**CHANGES TO RI/FS WORK PLAN DOCUMENTS**

**DOE-355-91  
DOE-FO/EPA  
2  
LETTER**

NOV 30 1990  
DOE-355-91

## DCR STATUS LOG

FIGURE 2

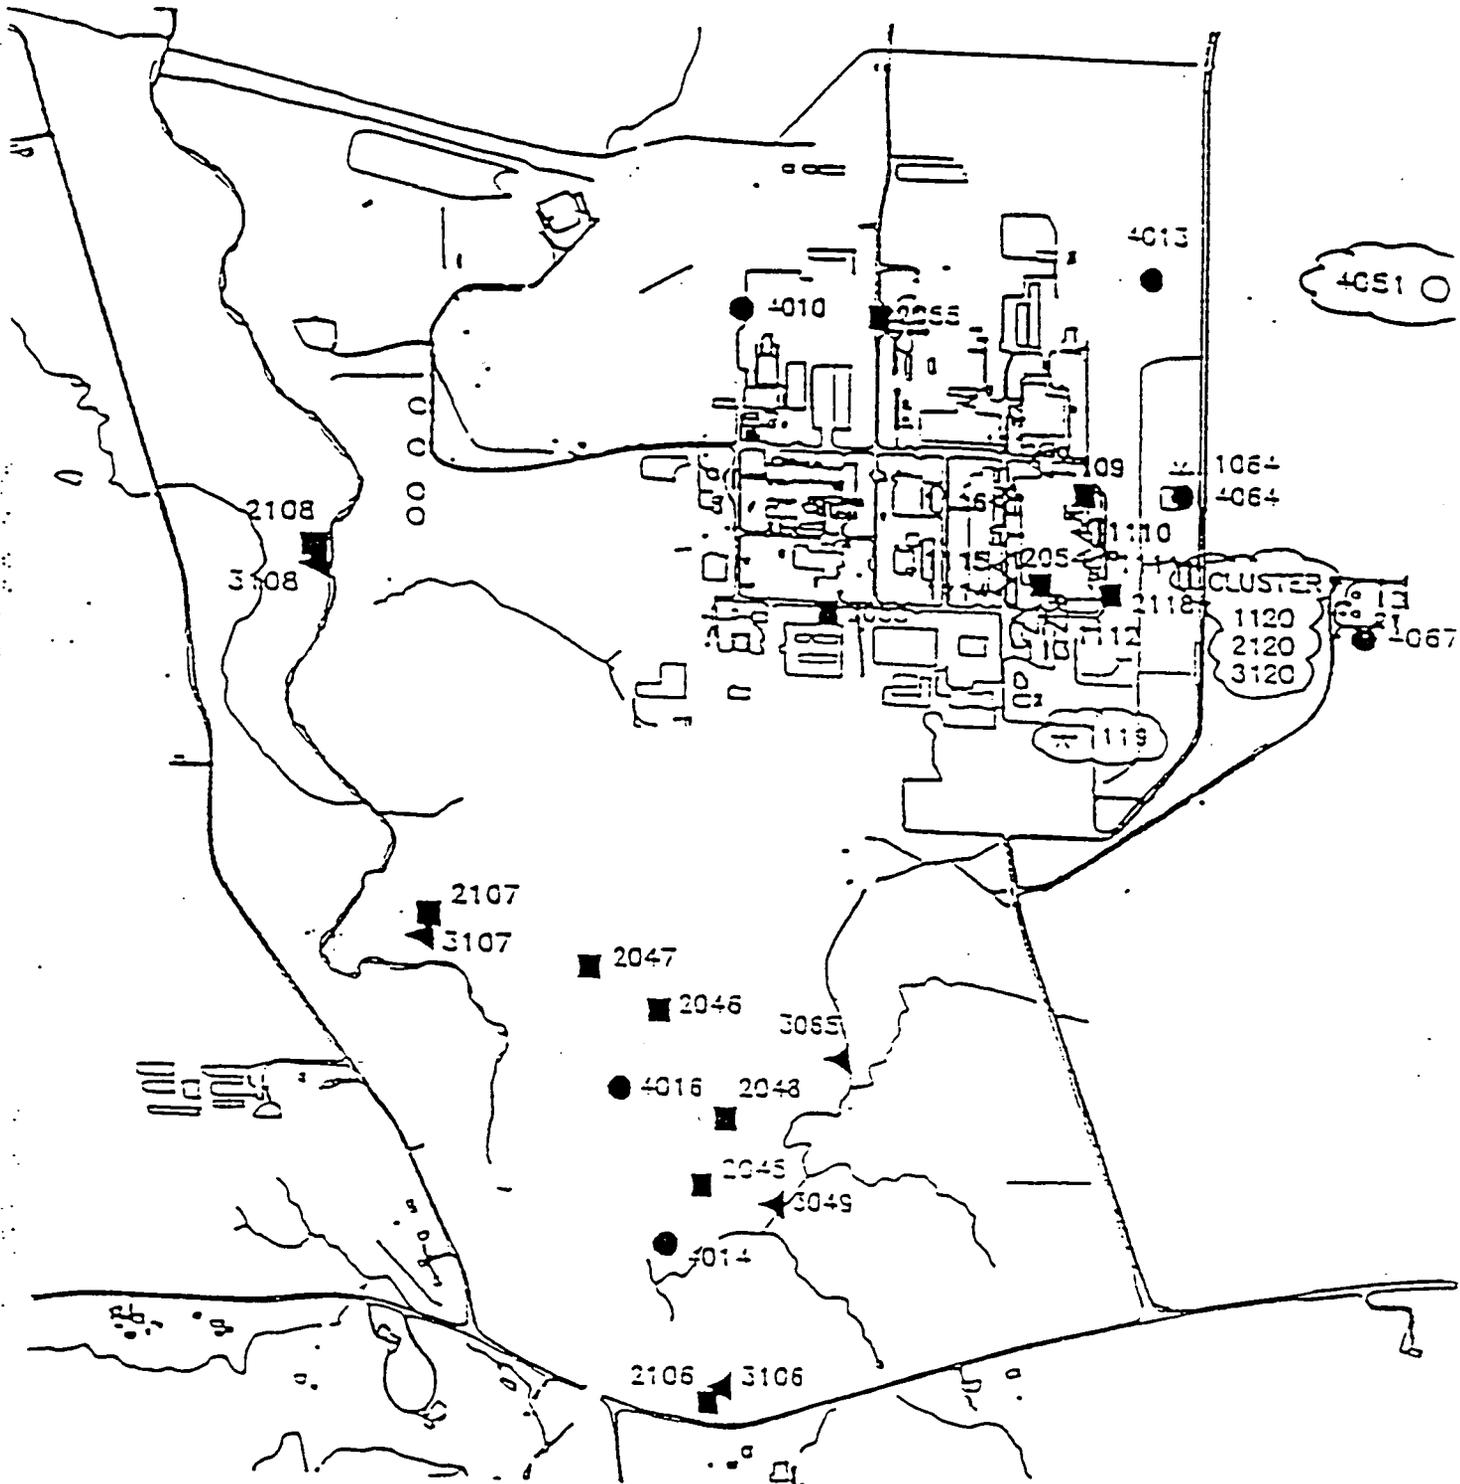
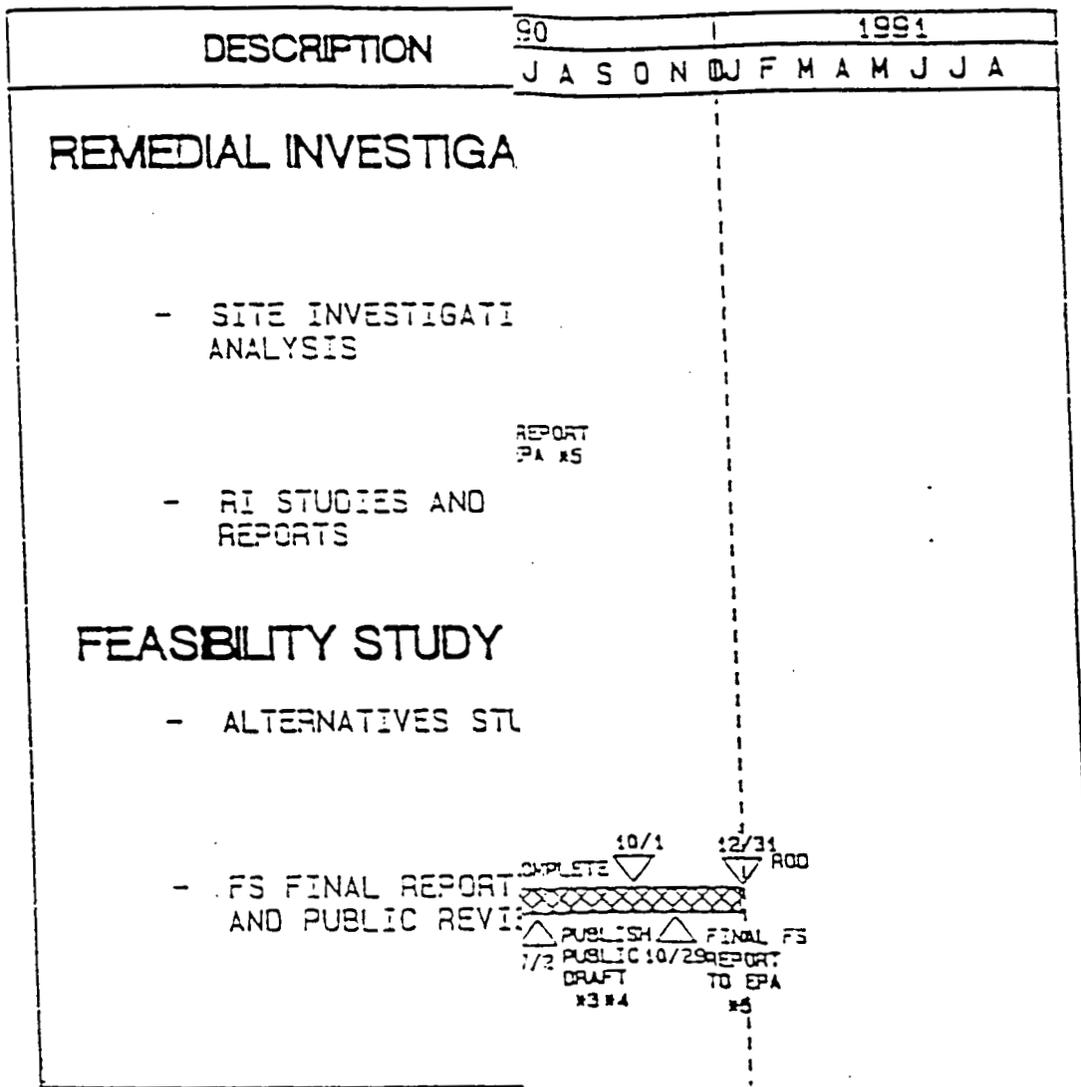
If elevated uranium concentrations are found in the 2000-series wells adjacent to Plant 6, an additional well cluster consisting of a 1000-, a 2000-, and a 3000-series well, will be installed east of Plant 6 as shown in Figure 2. The exact location of the cluster will be determined by the concentration of uranium in the wells and the local water table gradient.

Figure 1 shows the location of the eight borings that will be drilled around Plant 6. These borings will indicate the extent of the contamination in the vicinity of Plant 6. Previous investigations have found contamination under the building at the pickling area and at the south end of the building where a former sump leak occurred and was repaired. In the area south of Plant 6, borings are being placed to determine the extent of residual contamination from the sump leak. Contamination was known to have reached the sewer south of the plant, but there was no attempt to determine the extent of the contamination at the time. If these borings indicate a significant area of elevated uranium concentrations, an additional 1000-series well will be installed south of Plant 6 and north of the parking lots, as indicated in Figure 2.

WELL LOCATIONS  
EXISTING AND PROPOSED  
**FIGURE 1**

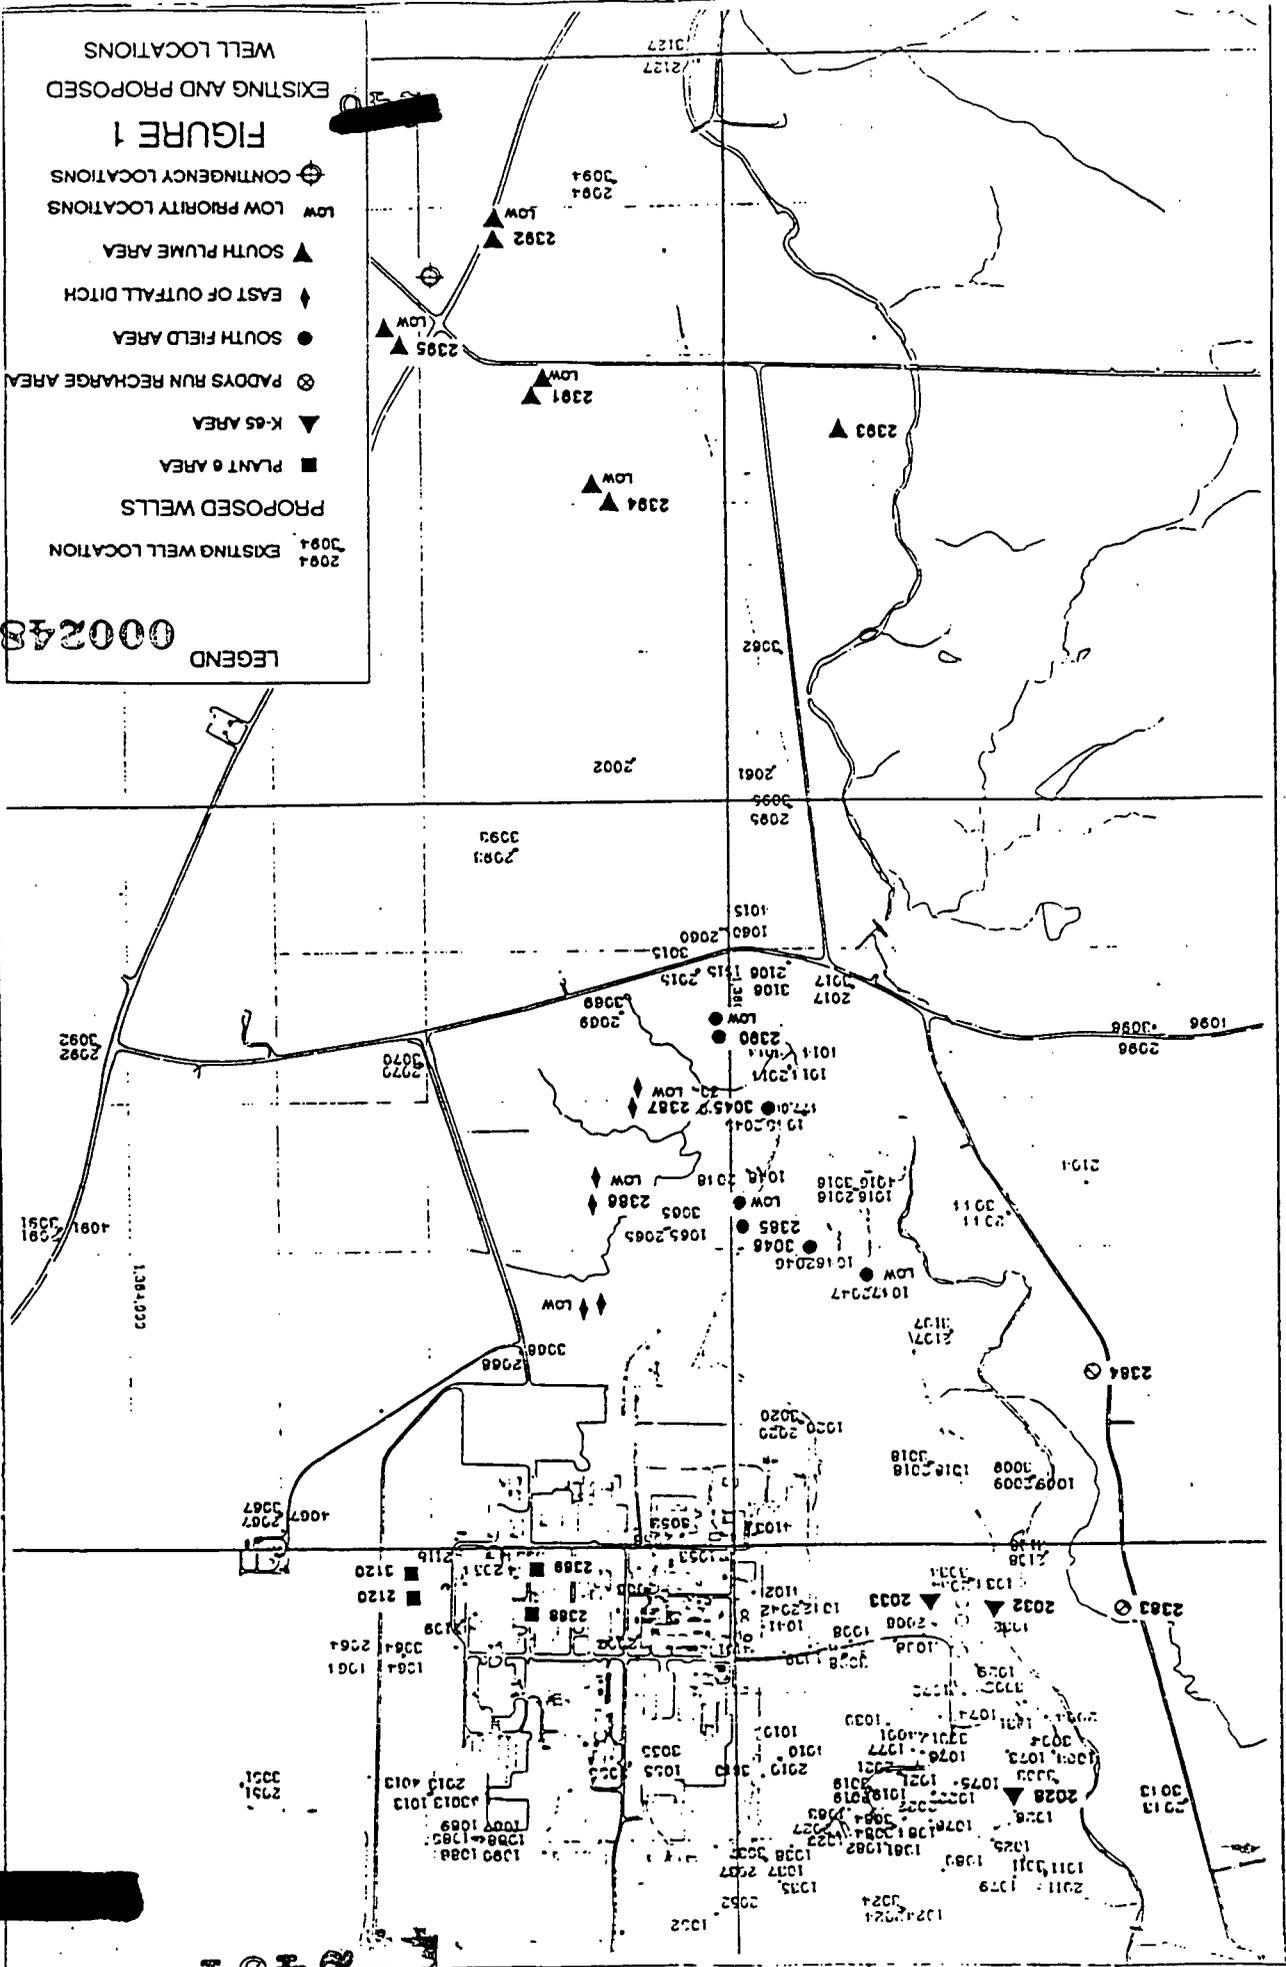
In addition, a condition of the Work Plan Addendum for the 24-well program specifies a well cluster on the downgradient side of Plant 6 if contamination is found in Wells 2118 or 2109. Since both of these wells indicate elevated levels of uranium, the well cluster should be installed to help define the plume. Given the east northeast ground water gradient in the area, wells 2120 and 3120 should be installed east of Plant 6 in the grass area in front of the new receiving warehouse as shown in Figure 1. This will help to bound the plume under Plant 6 to the east.

Two 2000-series wells are proposed for the western boundary of the FMPC as shown in Figure 1. Wells 2383 and 2384 will provide the water level and water chemistry data required to determine the significance and extent of the temporary ground water gradient reversal.

drilled in the area of the South Field as part of the 24-well program, have also shown elevated levels of uranium. As shown in Figure 1, wells 3046 and 3045 should be added to the existing well clusters to determine the vertical extent of the uranium plume present in the 2000-series well at these locations. These wells will satisfy a commitment made in the RI/FS Work Plan to install deeper wells if high levels of uranium are found in any wells. If uranium is detected in 3046, then an additional 3000-series well would be required at location 047, which is upgradient from location 046. Well 3047 is considered low priority.

**FIGURE 1**

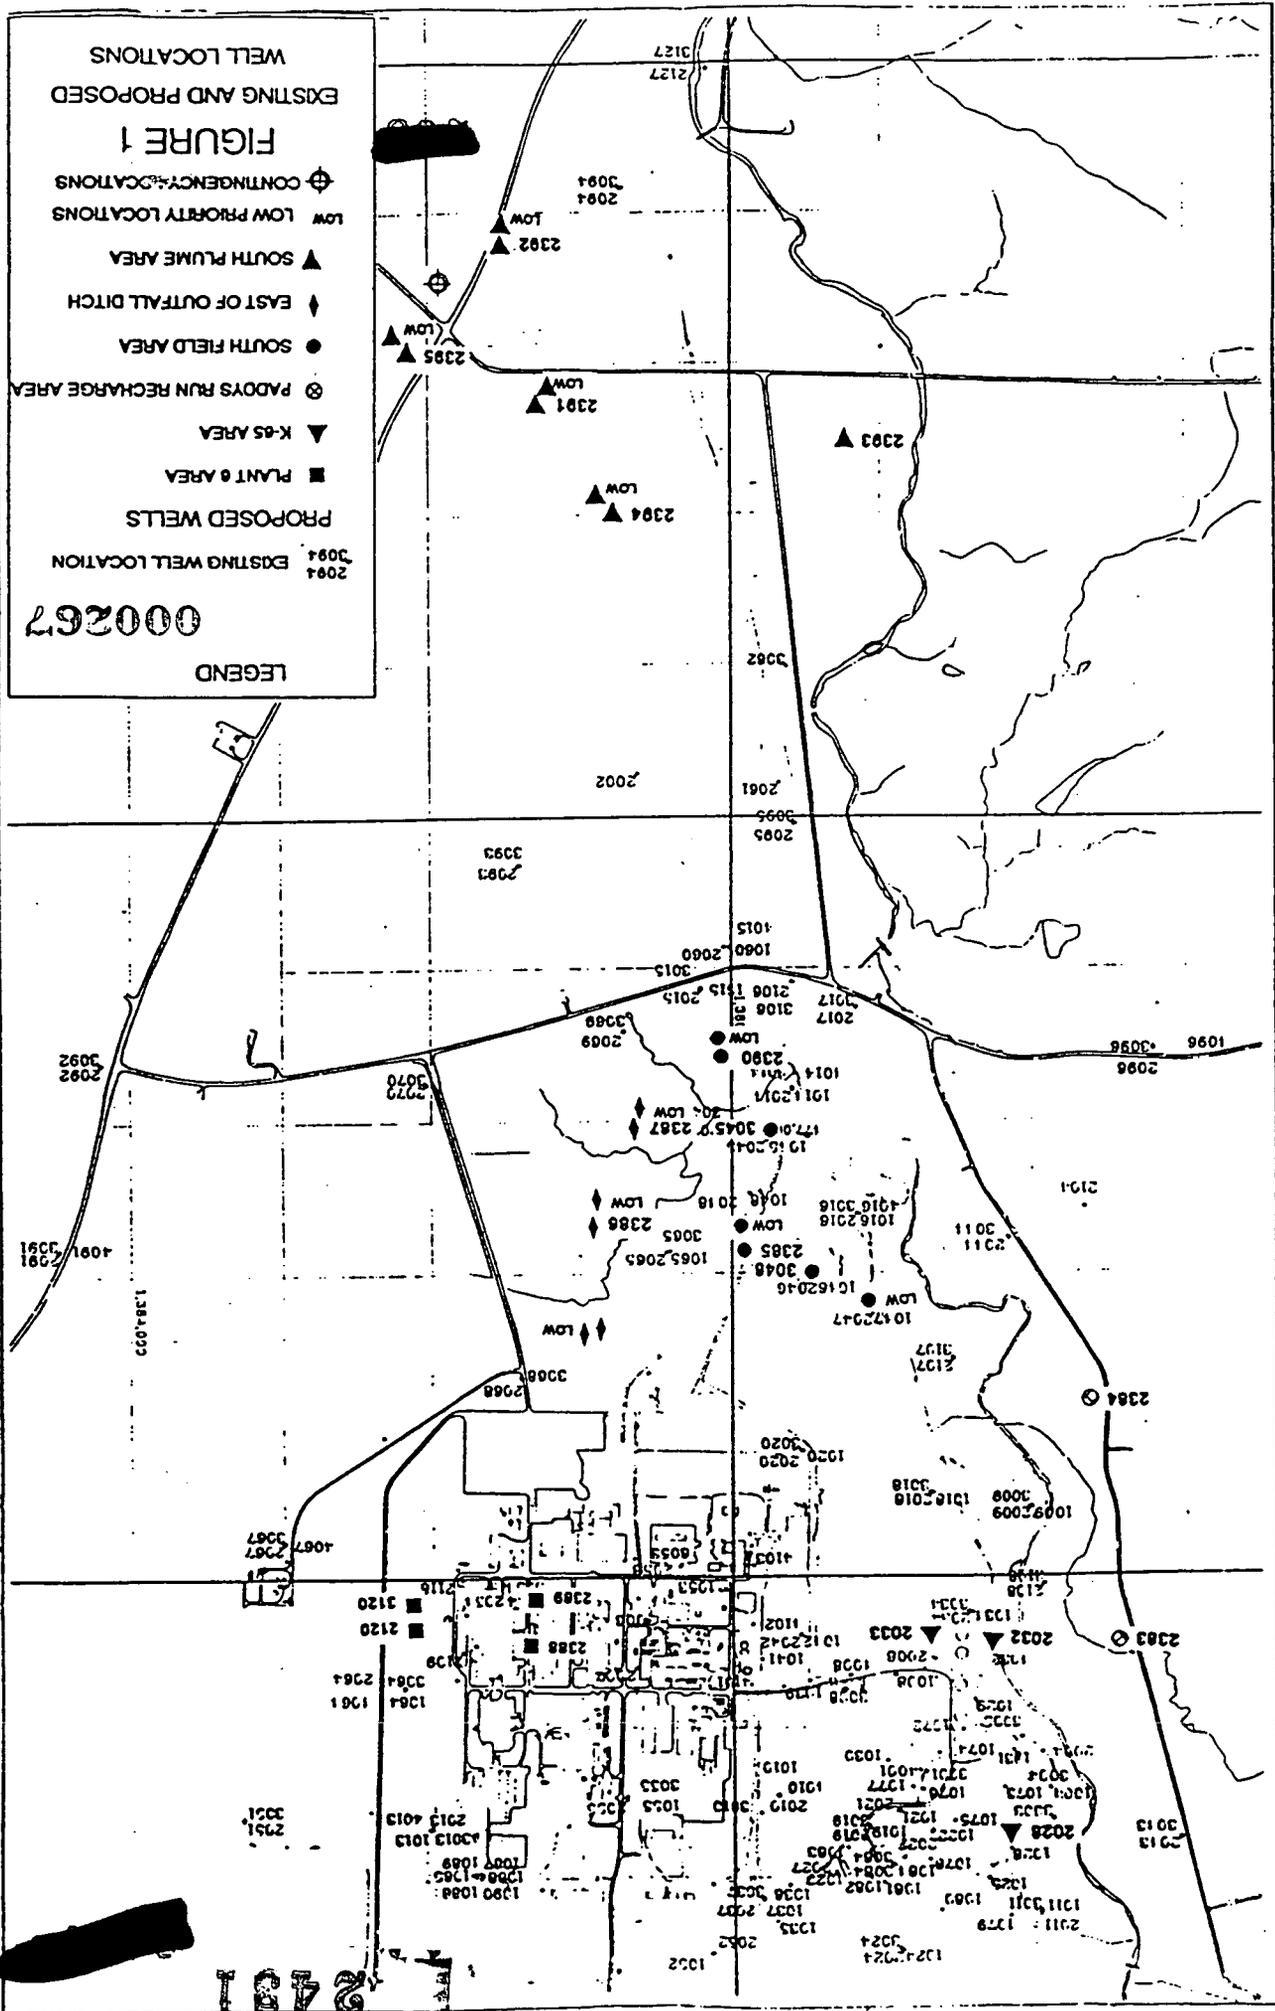
In addition, a condition of the Work Plan Addendum for the 24-well program specifies a well cluster on the downgradient side of Plant 6 if contamination is found in Wells 2118 or 2109. Since both of these wells indicate elevated levels of uranium, the well cluster should be installed to help define the plume. Given the east northeast ground water gradient in the area, wells 2120 and 3120 should be installed east of Plant 6 in the grass area in front of the new receiving warehouse as shown in Figure 1. This will help to bound the plume under Plant 6 to the east.

Two 2000-series wells are proposed for the western boundary of the FMPC as shown in Figure 1. Wells 2383 and 2384 will provide the water level and water chemistry data required to determine the significance and extent of the temporary ground water gradient reversal.

drilled in the area of the South Field as part of the 24-well program, have also shown elevated levels of uranium. As shown in Figure 1, wells 3046 and 3045 should be added to the existing well clusters to determine the vertical extent of the uranium plume present in the 2000-series well at these locations. These wells will satisfy a commitment made in the RI/FS Work Plan to install deeper wells if high levels of uranium are found in any wells. If uranium is detected in 3046, then an additional 3000-series well would be required at location 047, which is upgradient from location 046. Well 3047 is considered low priority.
